Appln. Serial No. 10/697,154
Amendment dated 9/22/05
Reply to Office action of 06/22/2005

Amendments to the Drawings

REMARKS/ARGUMENTS

FIG. 29

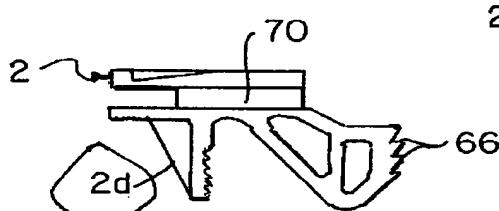
The attached 6 sheets of drawings includes changes to Figs. 29, 33, 34, and 35. These sheets replace the original sheets including Figs. 1-39. In Fig. 29, reference numeral "2d" has been changed to - 2c --, and in Fig. 33, previously omitted reference numeral -- 76 -- has been added. In Fig. 34, the lead line for reference numeral 66 has been added, and in Fig. 35, reference numeral "104" has been changed to - 104a --, and reference numeral -- 104 -- has been added.
